Amendment to the Drawings:

Transmittal of the replacement sheet for formal drawings of FIG. 1.

Attorney Docket No. 039592-001200

Application No.: 10/719,504

FIG. 1

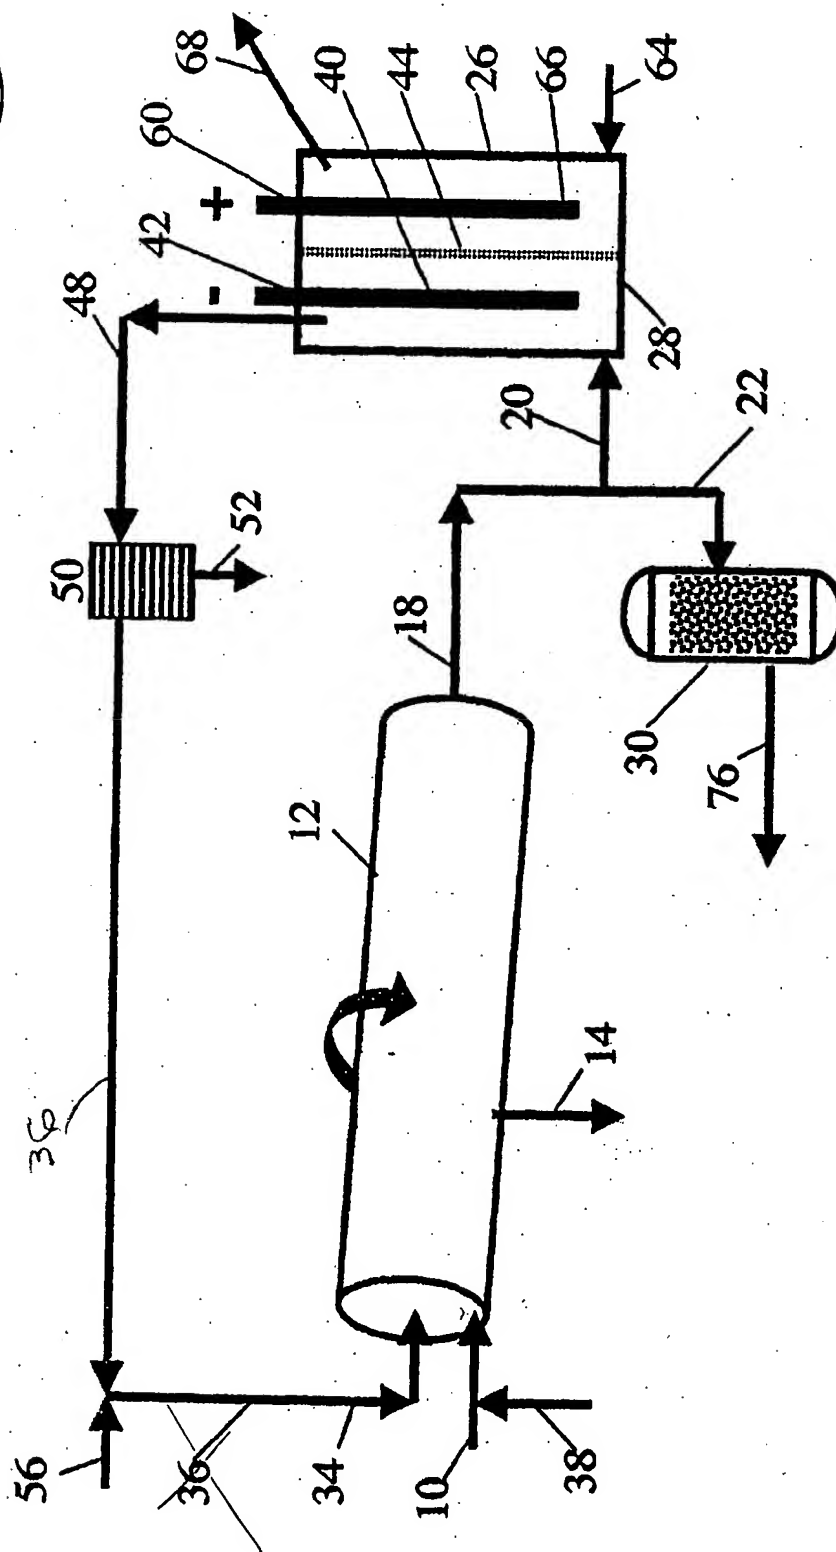
The attached sheet of formal drawing of FIG. 1 replaces the previous formal drawing of FIG. 1 submitted with the parent application filed November 21, 2003. The attached sheet of the formal drawing of FIG. 1 corrects the misalignment of lead line 36 so that, instead of leading to line 34, line 36 now leads to the line running between line 56 and condenser 50. This change does not introduce new matter.

FIG. 1 has been amended to correct the misalignment of a lead line and a new formal drawing of FIG. 1 has been attached.
